**ONTARIO ENERGY BOARD  
IN THE MATTER OF AN APPLICATION BY  
HALTON HILLS HYDRO INC. (“HHHI”)  
2021 COST OF SERVICE APPLICATION  
INTERROGATORY RESPONSES FROM HALTON HILLS HYDRO INC.**

**DISTRIBUTED RESOURCE COALITION INTERROGATORIES AND RESPONSES**

**Table DRC IRR – 1 – Potential for EV Sales**

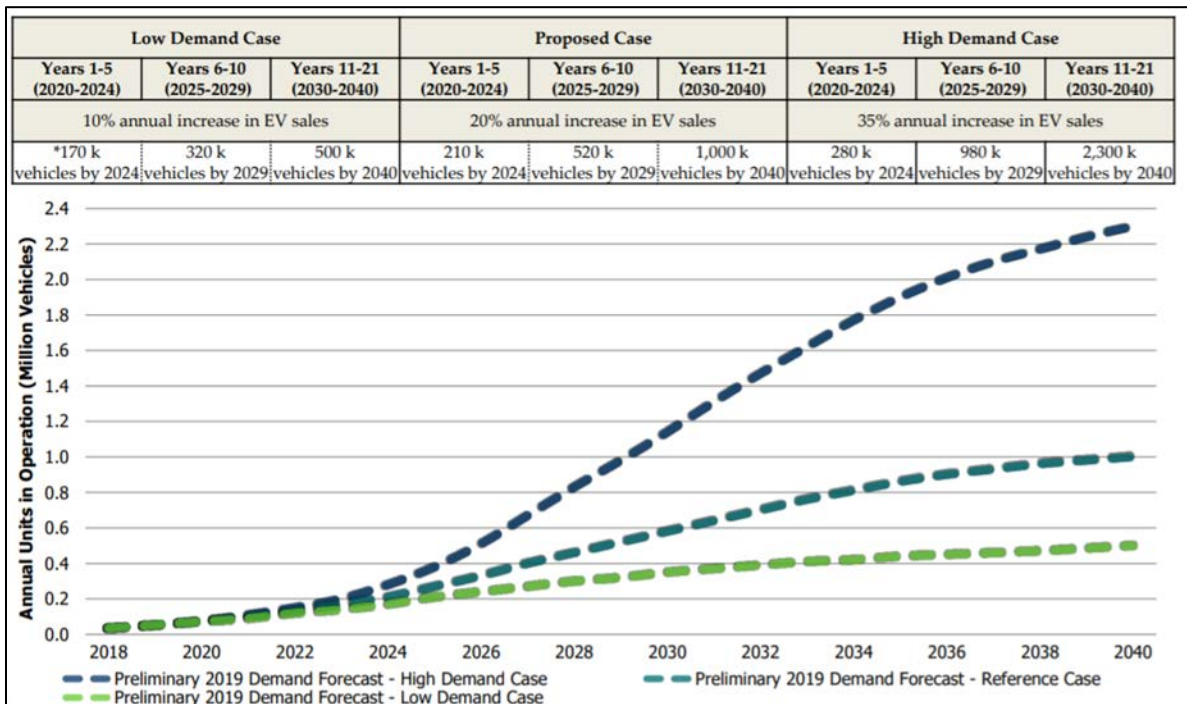
- f) Please provide your assessment of the specific impacts of the growing consumer interest in EVs and associated increase in EV penetration in HHHI’s service territory, on (i) HHHI’s distribution system planning, (ii) load forecast, (iii) productivity, and (iv) OM&A costs.

Table DRC IRR – 1 – Potential for EV Sales is from the IESO Preliminary Long-term Demand Forecast 2019 and reflects a potential for significant increase in EV sales over the next 20 years.
